Process Sheet

: CU-DAR001 Dart Helicopters Services

: END CAP **Drawing Name**

Part Number . D2208 REV B **Drawing Number**

END CAP

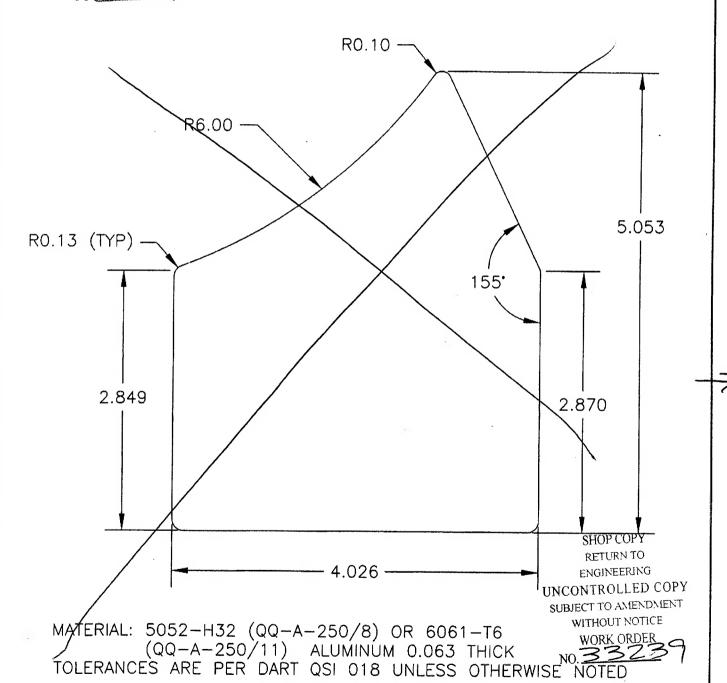
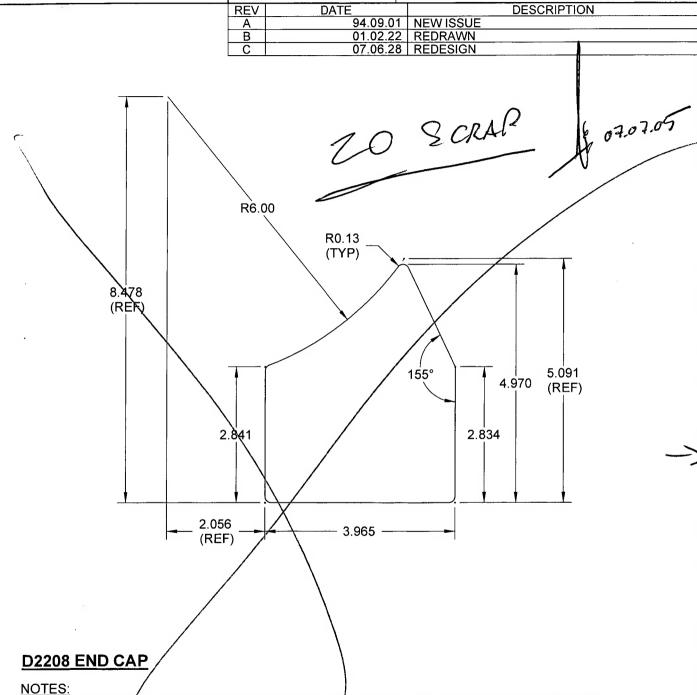
NCR:		WORK ORDER NON-CONFORMANCE (NCR)									
		Description of NC		Corrective Action Section B		Verification	Approval	Approval			
DATE	STEP	Section A	Initial Action Description Chief Eng		Sign & Date,	Section C	Chief Eng	QC Inspector			
celectes	# 20 WARD	one part DCAP. Water Set out inside the part leaving a small grove in the part CL past more	Pasions	MP sala cal	MALL B OT PT B3	Er	Posiour	20 07/07/0			
	•						÷

D2208 END CAP

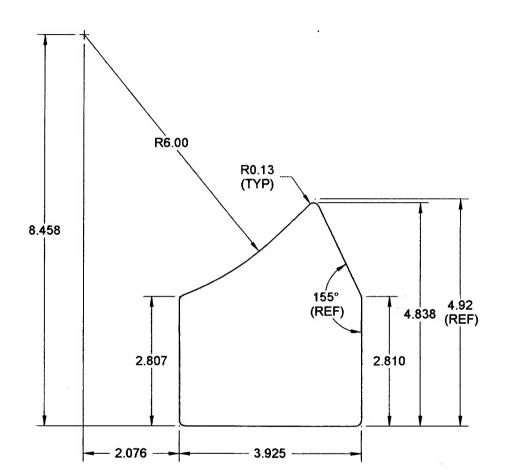
W/O:		WORK ORDER CHANGES									
DATE	STEP	PROCEDURE CHANGE	Ву	Date	Qty	Approval Chief Eng / Prod Mgr	Approval QC Inspector				
ottotte	#20 1 23,0	Remore sker 2.0 And is now cut on water Det change from HAAS to WATER jet and ADD dubur sti	Cr.	otherlos							
4

07.07.05 REDESIGN
